Re: **Copper World Operations; Aquifer Protection Permit No. 513690, LTF 90620**

Copper World Aquifer Protection Permit: Pima County Staff Comments

Staff have reviewed the application materials submitted by Hudbay Minerals as well as the proposed Copper World Aquifer Protection Program (APP) draft permit # P-513690. The following comments are submitted on behalf of Pima County, Pima County Regional Flood Control District, Pima County Regional Wastewater Reclamation Department, and Pima County Department of Environmental Quality, collectively referred to here as Pima County. The comments are organized in the order of the draft permit terms.

FIGURE 16-7: SECTION A-A' – EAST PIT MINE PHASES

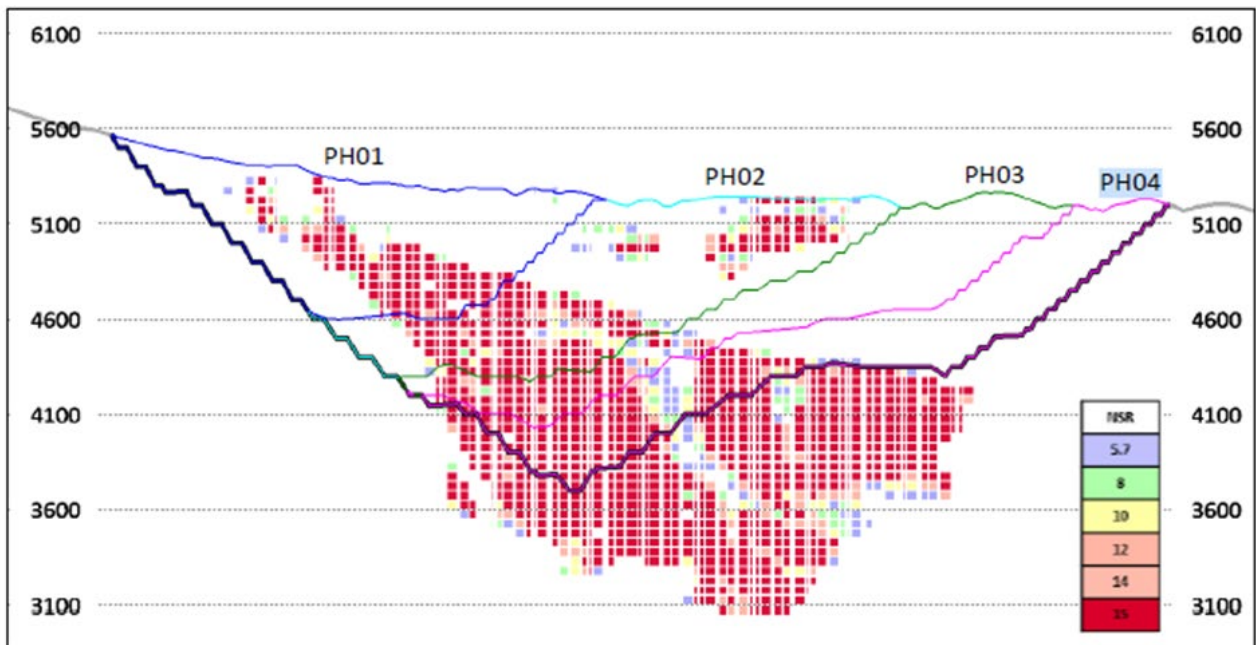
3. Pima County requests the addition of the East Pit as an APP-regulated facility under the Copper World permit. ADEQ is obligated to evaluate whether or not the East pit is a discharging facility under A.R.S.§49-241.A. It is claimed in the application and supported by studies that the Rosemont Pit will eventually become a hydraulic sink, and is therefore not a discharging facility. However, this behavior of hydraulic sink will take time to establish. During initial pit construction and operation, the pit may not act as a hydraulic sink. The applicant has not demonstrated that the discharged pollutants will be captured and hydrologically isolated in the depressed water table around the pit at early timeframes. Additionally, the use of the dewatering volume used to maintain the hydraulic sink during closure and post-closure have not been addressed.

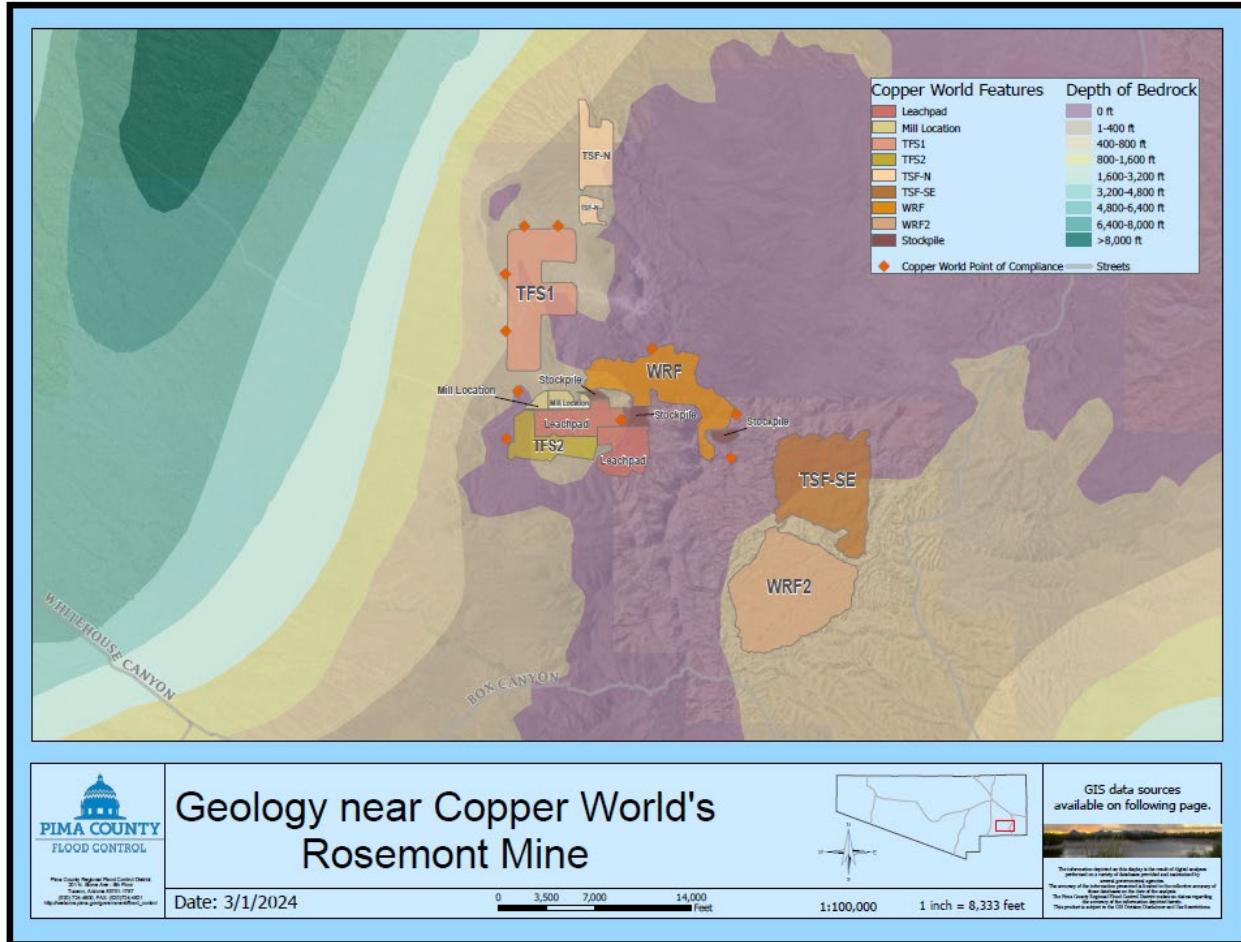
The figure below provided by Pima County Regional Flood Control District shows the depth to bedrock. There is a large drop off in the bed rock which goes to 400-800 feet. This demonstrates the varied site conditions and the possibility for leakage through the bedrock and directly into the aquifer. The site-specific conditions given in the draft permit are inappropriate and are inadequate in managing pollution in the TSFs.

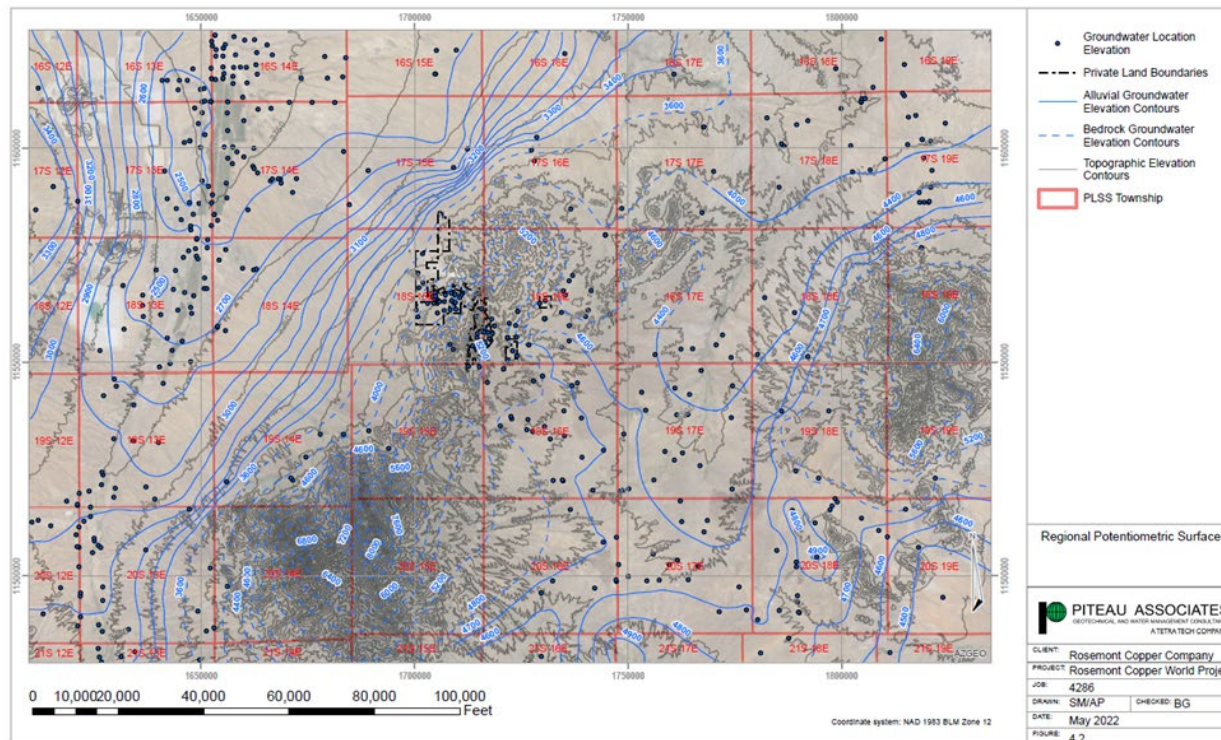
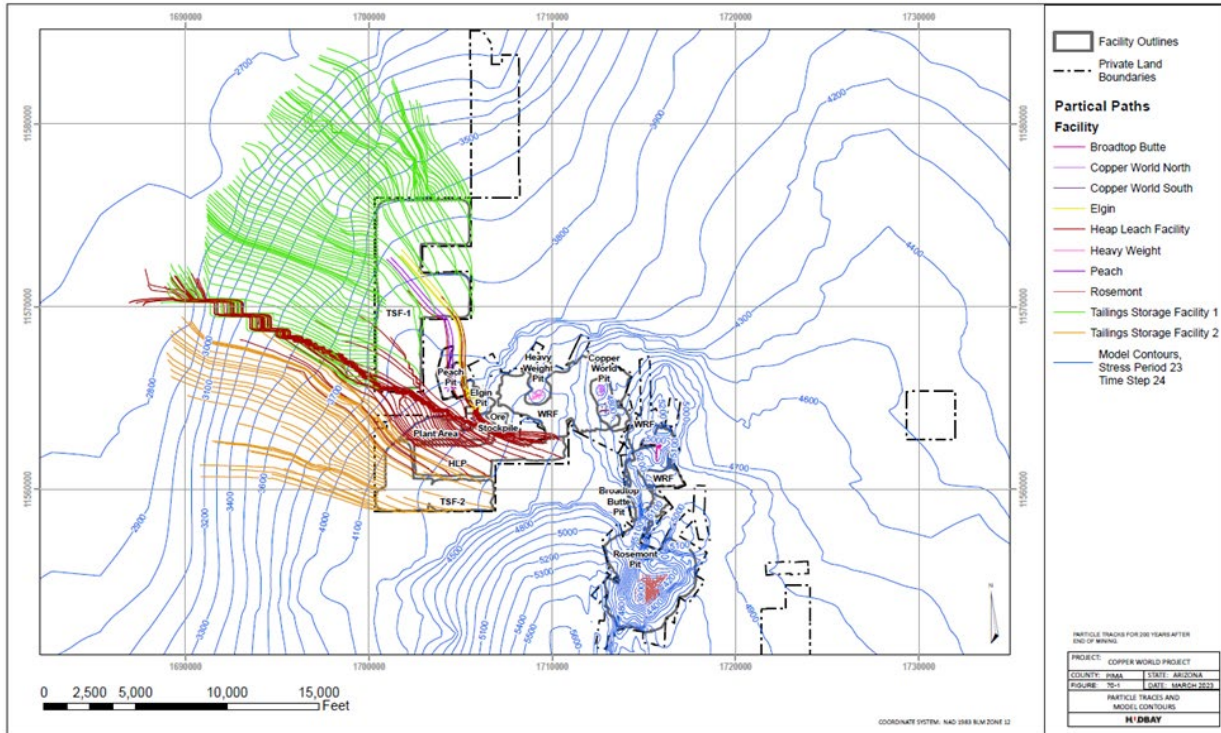
The particle traces and groundwater model contours as displayed in Figure 70-1 (below) from Attachment 31 of Hudbay’s response to ADEQ’s initial RAI is useful in demonstrating the hydraulic gradient and the mobility of pollutants discharged at certain points within the PMA. Not only does this figure demonstrate a clear hydraulic gradient to the northwest of the TSFs with the blue contour lines, but it also confirms via the particle traces (in red and green) that there is significant pollutant mobility for the TSFs and the HLP. The hydraulic gradient is again confirmed by Figure 4.2 (below) of Appendix F.1.

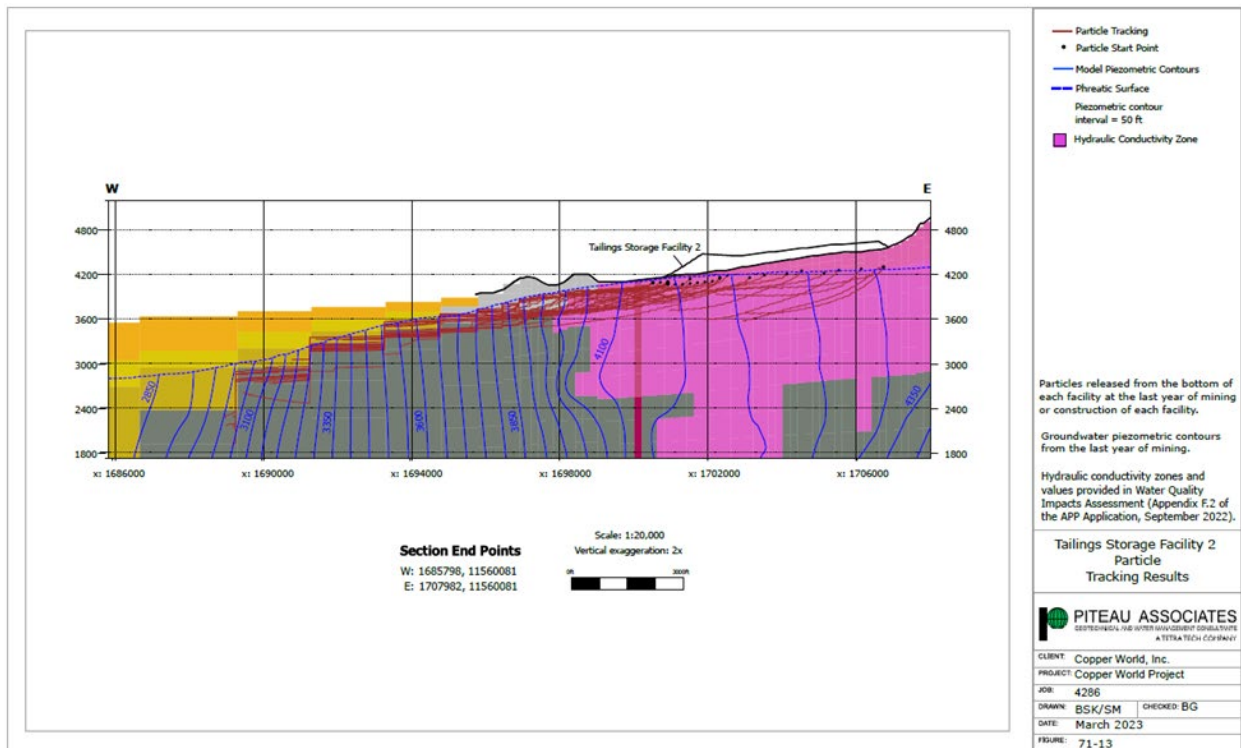
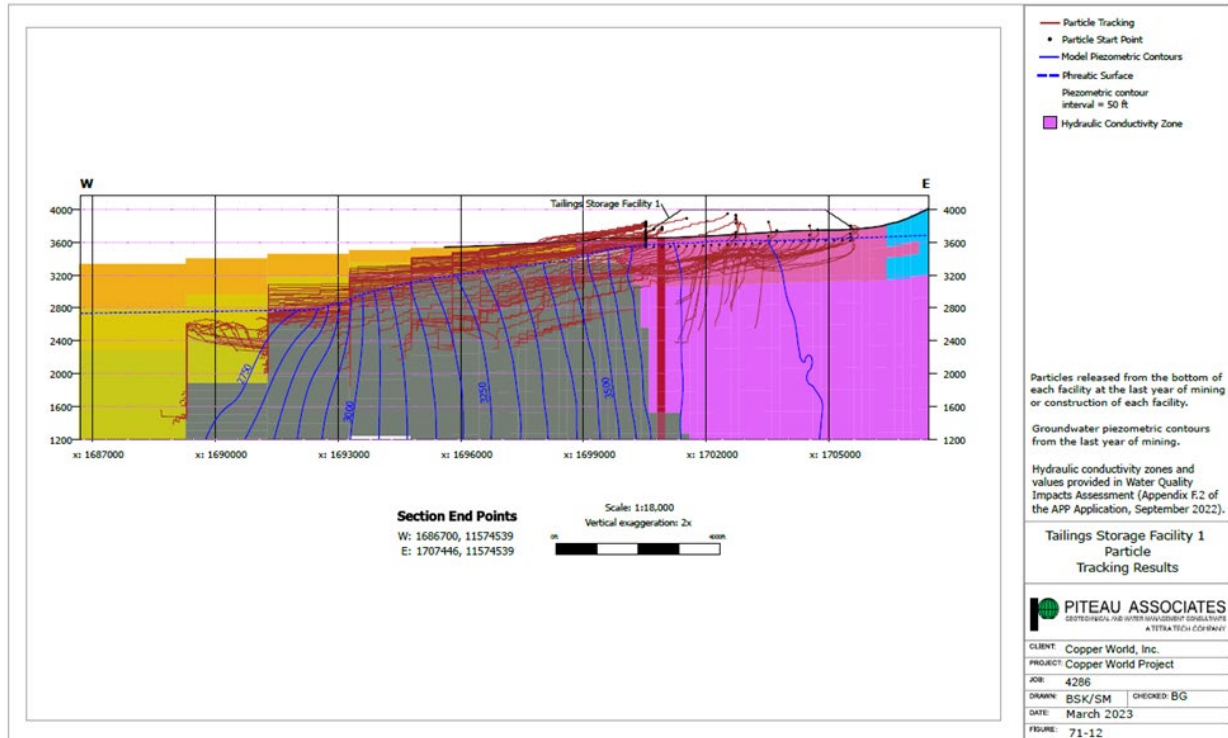
Additionally, Figures 71-12 and 71-13 (below) from Attachment 32 to Hudbay's response to ADEQ's initial RAI show the cross-sectional particle traces for TSF-1 and TSF-2, respectively, and further demonstrate the high mobility of pollutants downward and laterally. In the traces

below, the model shows pollutants moving down and through the alluvium unit towards the Tucson Basin aquifer. The dashed line in these documents is the phreatic surface, and it represents the depth to water. When a particle tracking line has passed below the phreatic surface, it has effectively entered the aquifer. This should be no surprise, as it was previously stated that the depth to water above the TSFs is only 20 to 48 feet. It can be seen that particle tracing lines nearly immediately cross the phreatic surface, and thus nearly immediately enter the aquifer. Another potential direction of movement would be in the alluvium just above the bedrock contact until it reaches the adjacent basin fill units. The model did not represent thin alluvial unit which underlies the TSFs, which eliminated any consideration of this potential.
